PROPOSED REVISIONS TO CROSSING OF  
NIAGARA - ST. CATHARINES - TORONTO  
ELECTRIC RAILWAY OVER  
THE QUEEN ELIZABETH WAY  
CITY OF ST. CATHARINES, DISTRICT NO. 4  
W.P. 224-61

FOUNDATION INVESTIGATION REPORT

ADDENDUM NO. 1

January 4, 1962

**REVISED**  
JANUARY 4, 1962

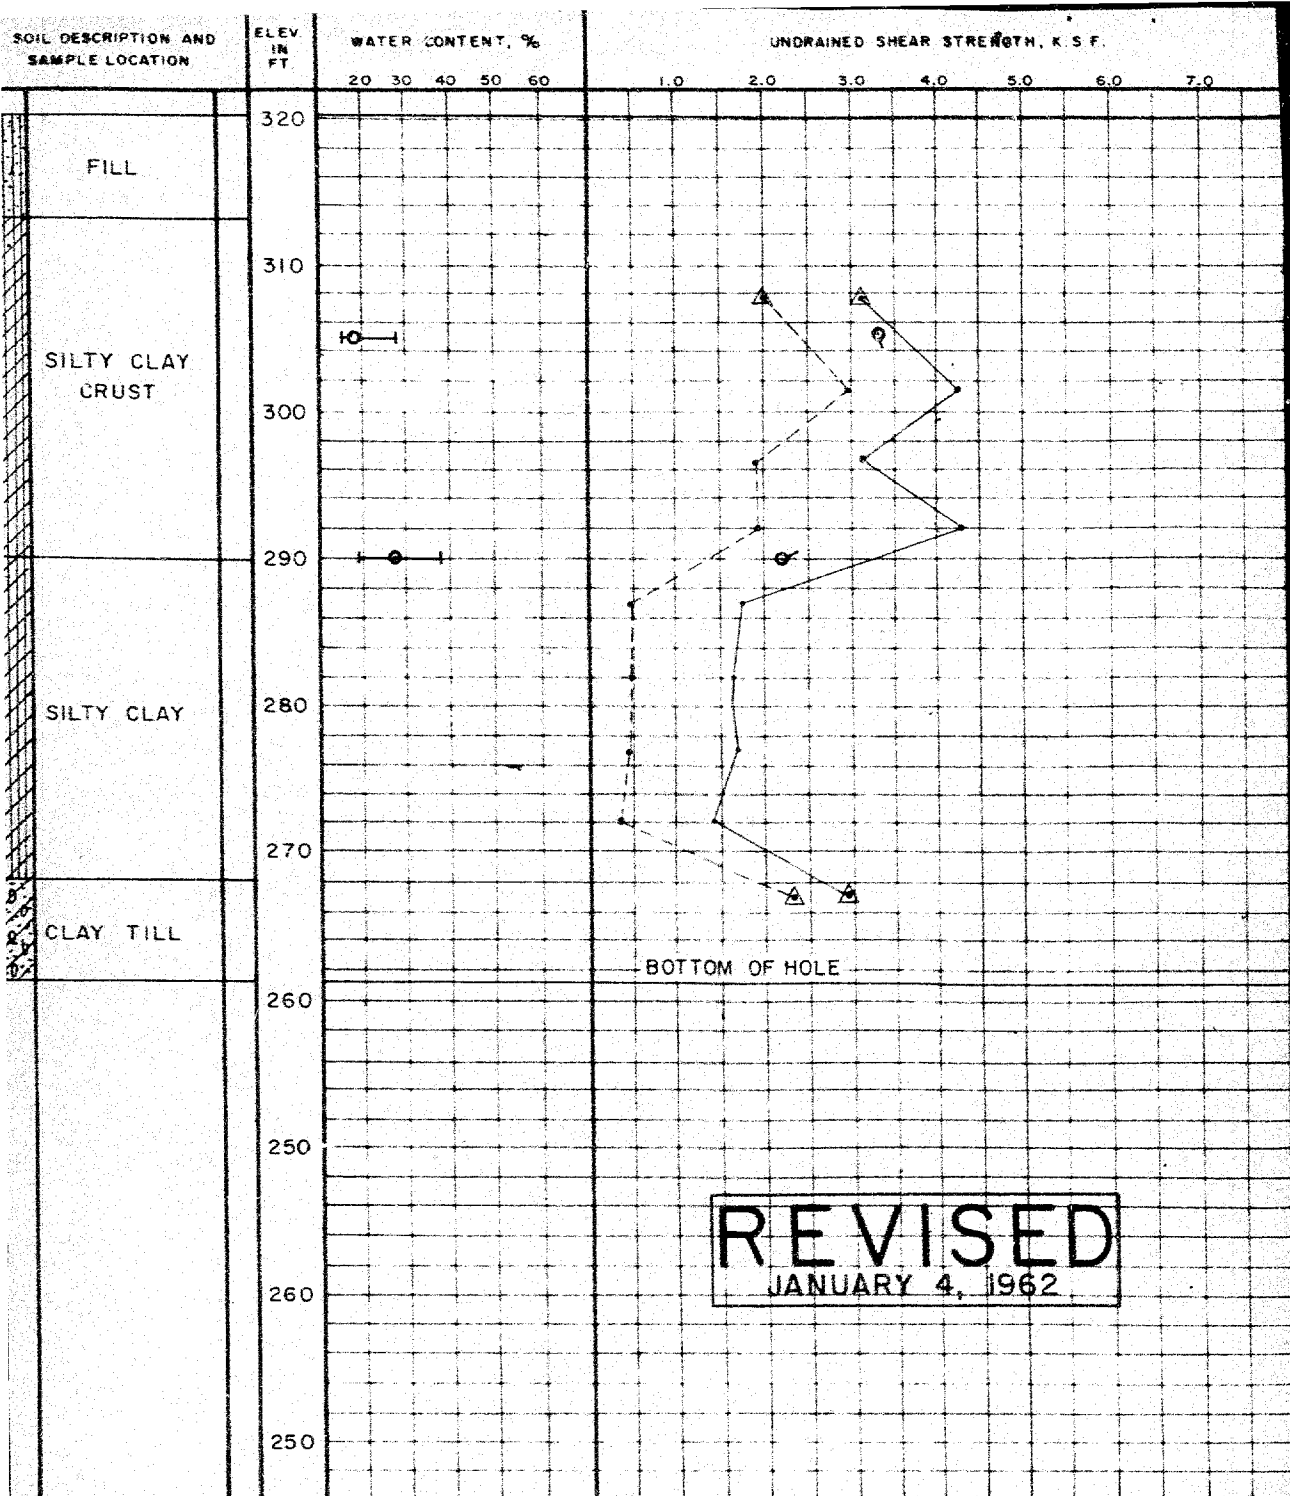
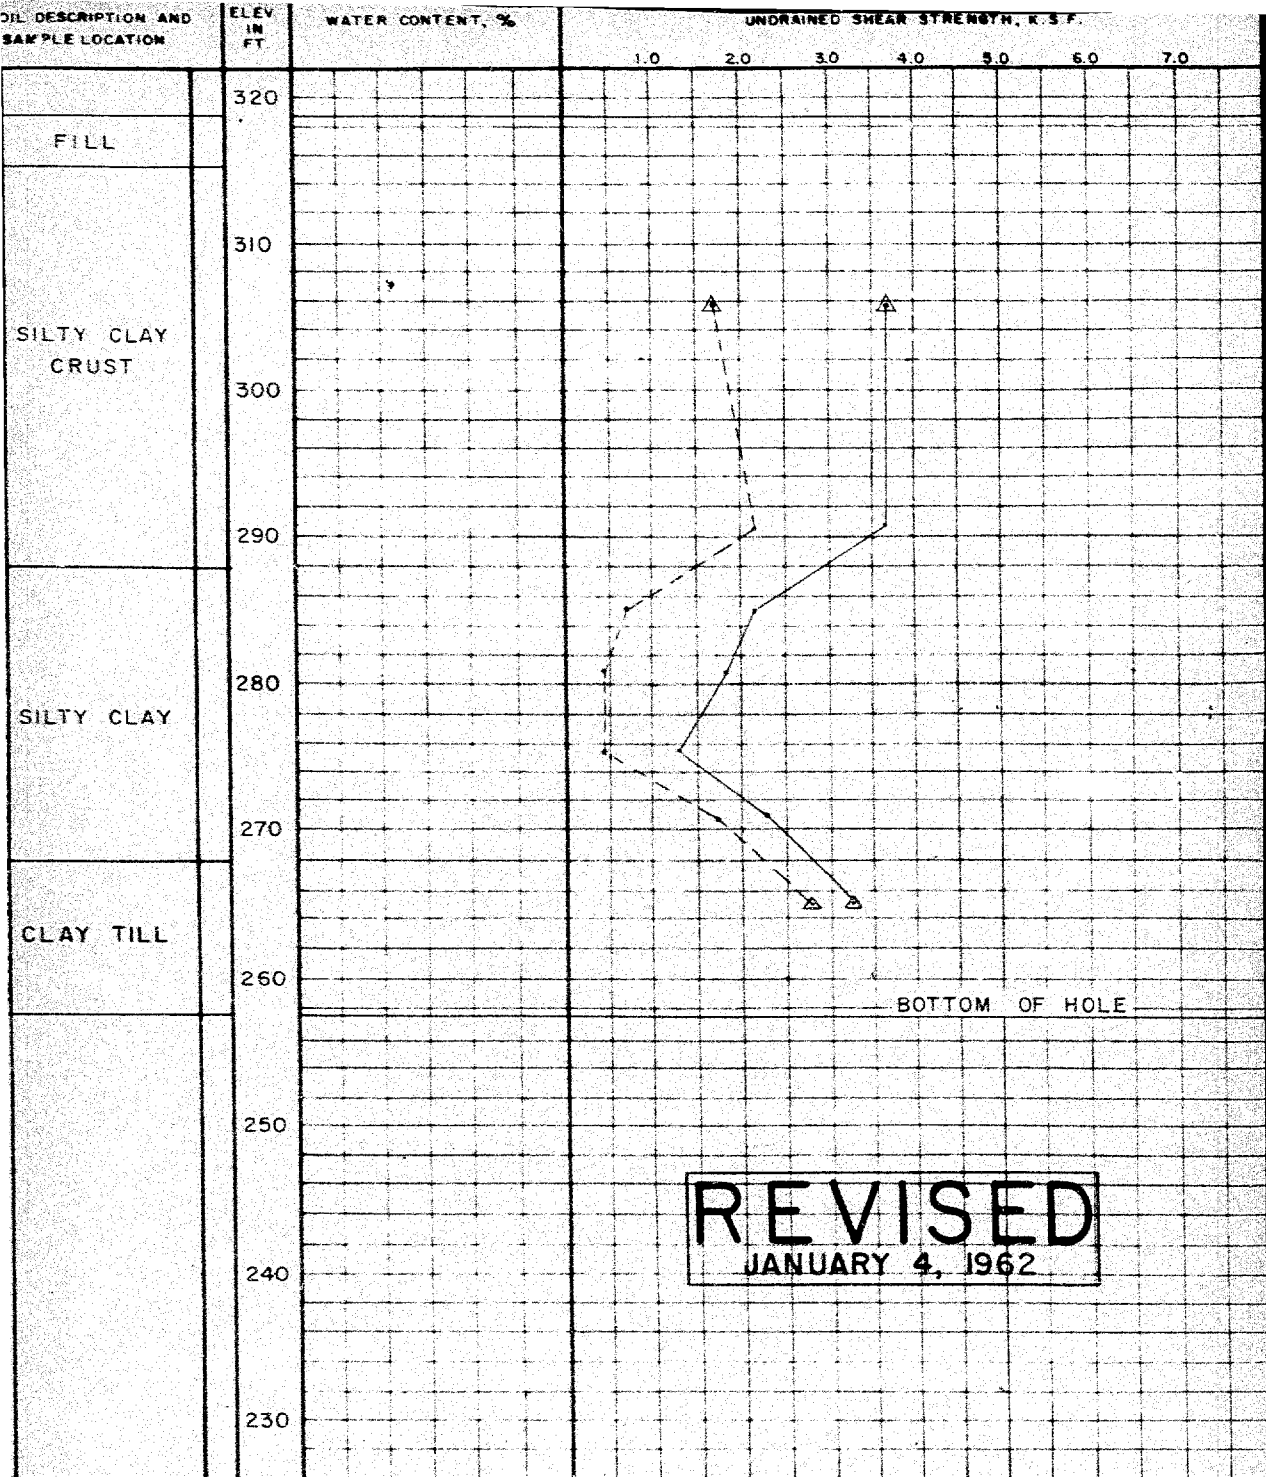
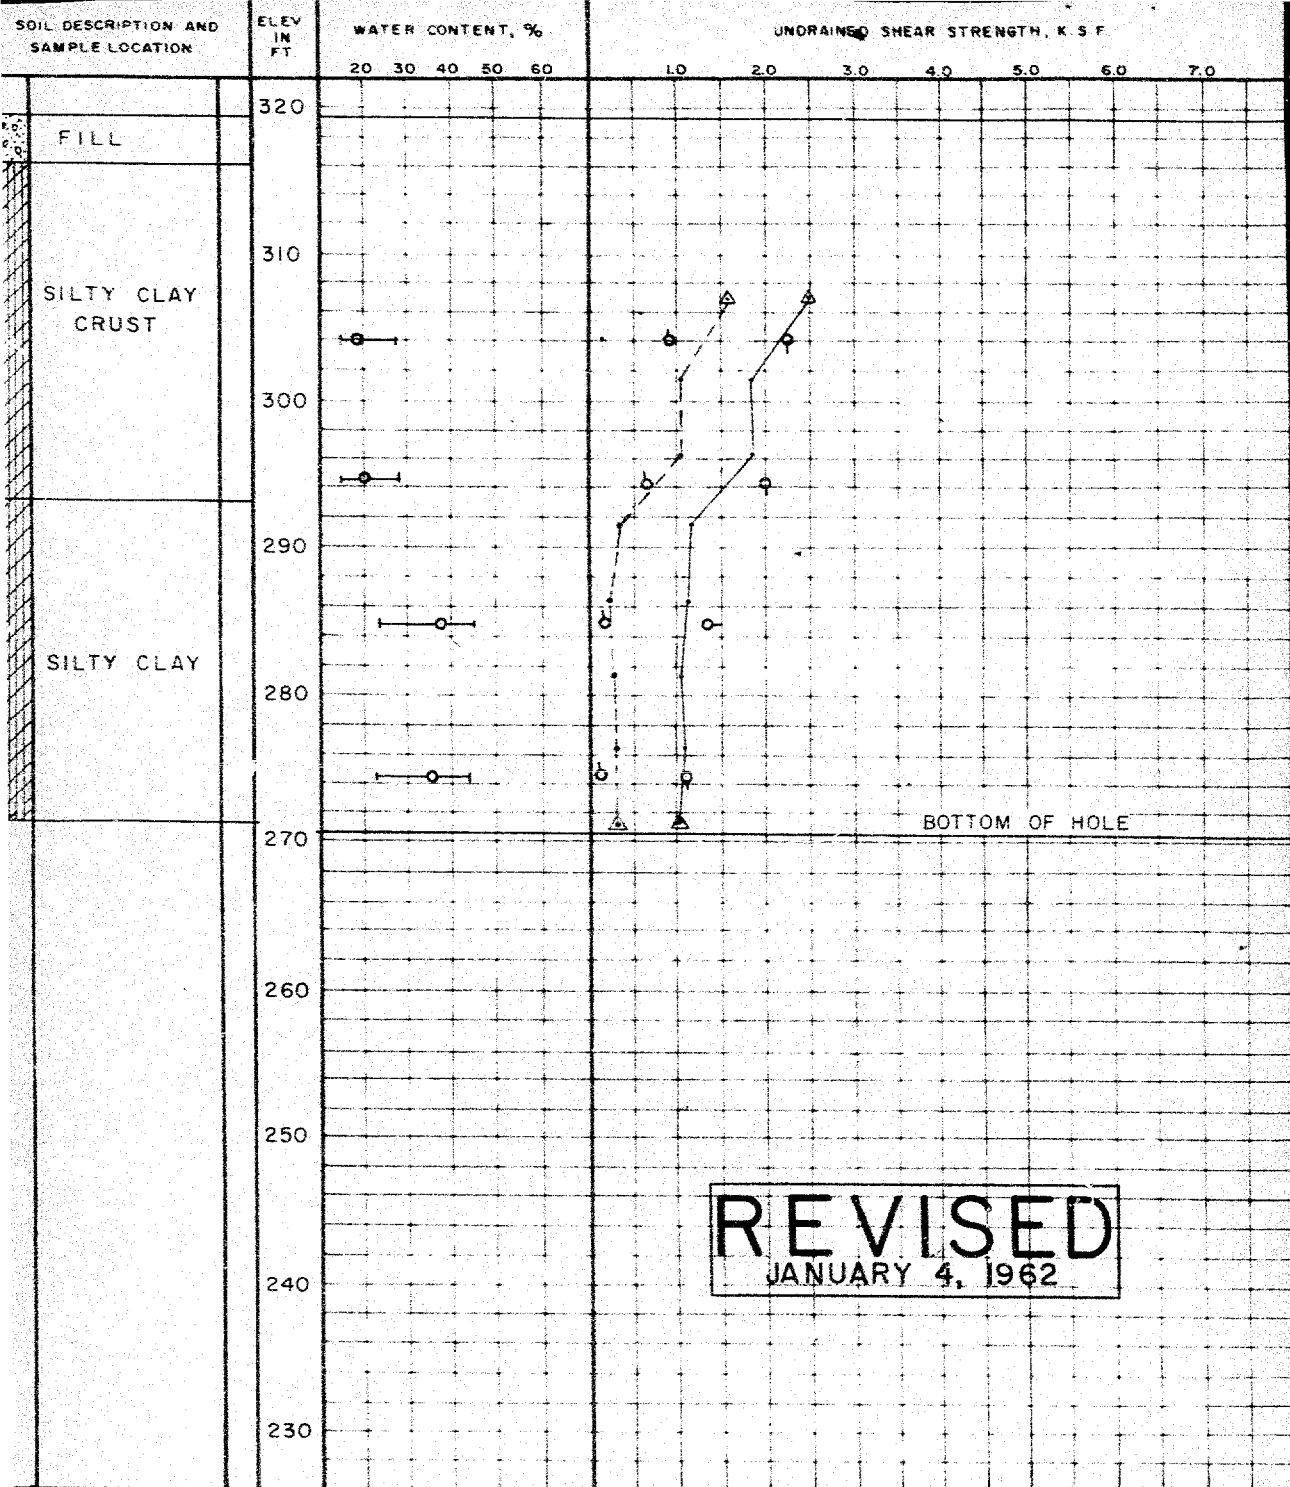
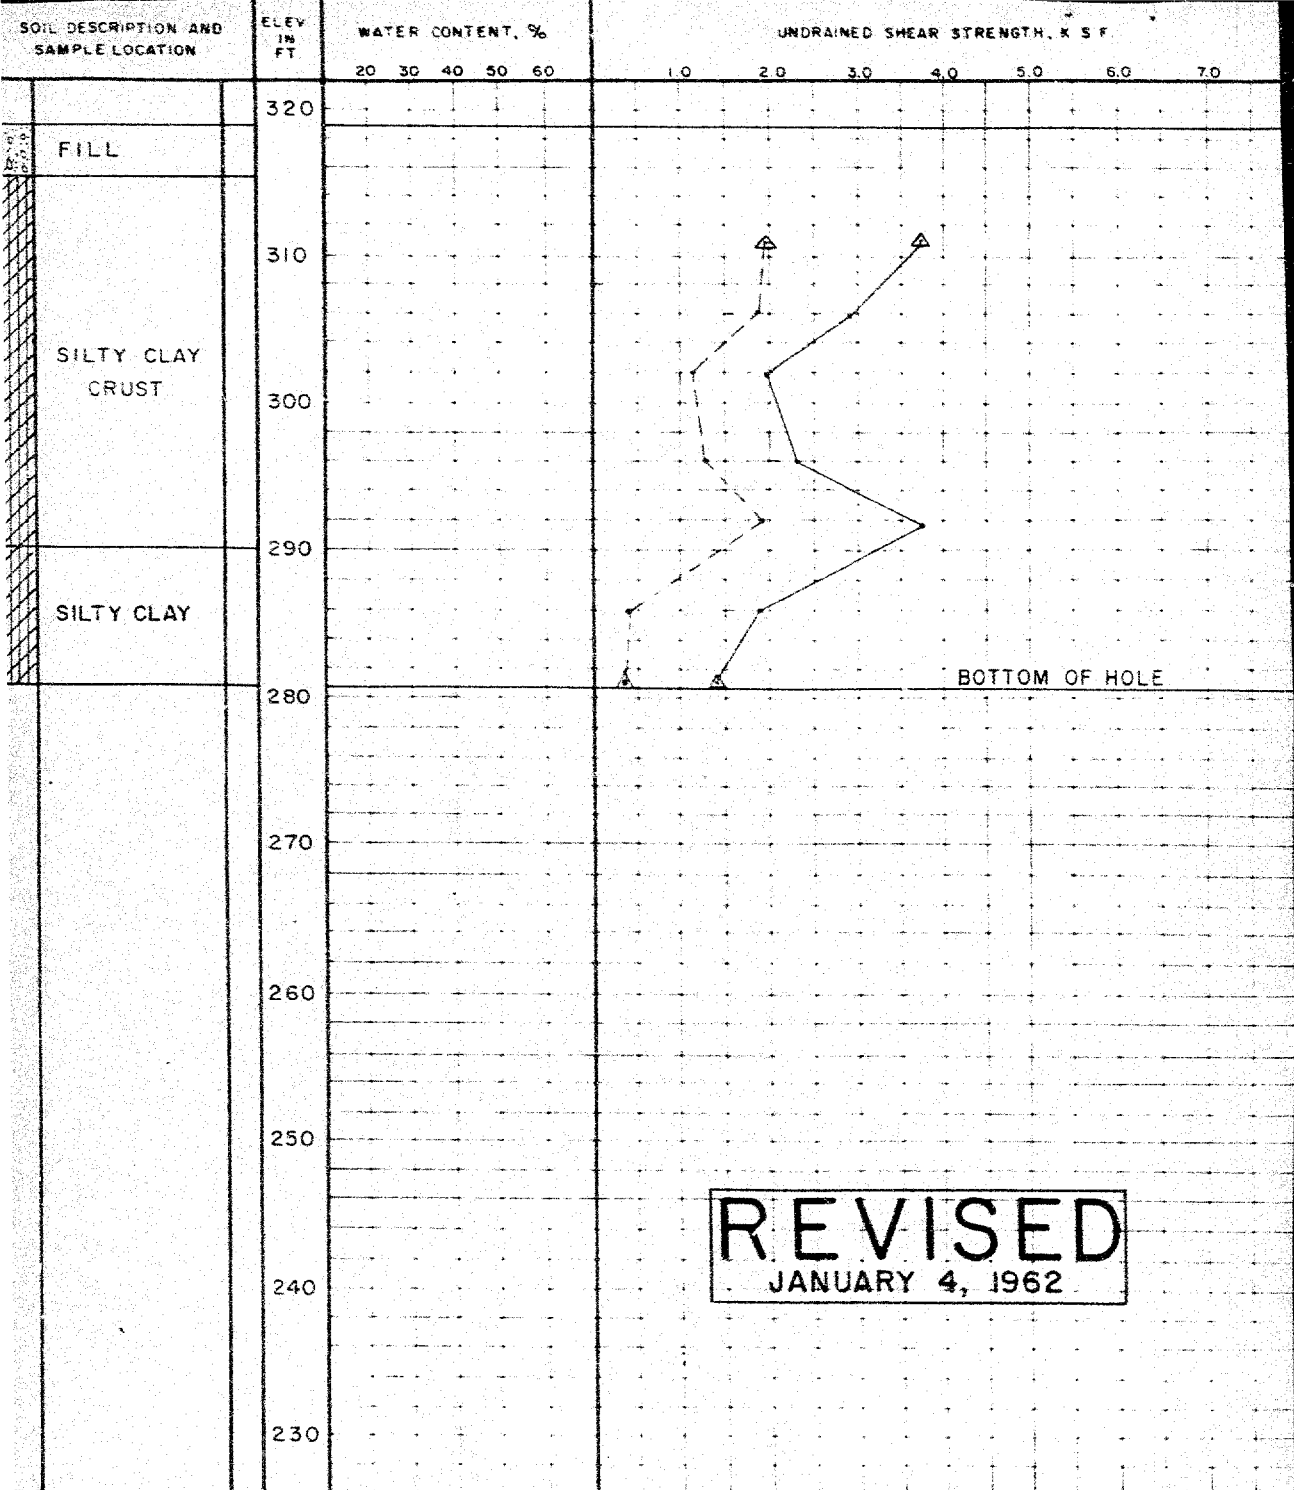
You will recall that in our report on the foundation investigation at the above site we pointed out an apparent anomaly between the laboratory unconfined compression tests and the field vane tests. In hole 954-3 the results of the laboratory tests gave higher values for the natural undrained shear strengths than the field vane tests.

A further investigation of this apparent anomaly has revealed that an error existed in the calibration of the torque wrench with which some of the vane tests had been performed. The results of the vane tests have been re-evaluated and an addendum with the corrected data is attached. These changes do not altogether reverse the original condition with respect to the test results. However, it is considered that any discrepancies can now be explained simply by scatter in the results.

The magnitude of the changes do not have any practical effect on the design considerations. Therefore, our report remains essentially unchanged.

\* These values are changed from original report.
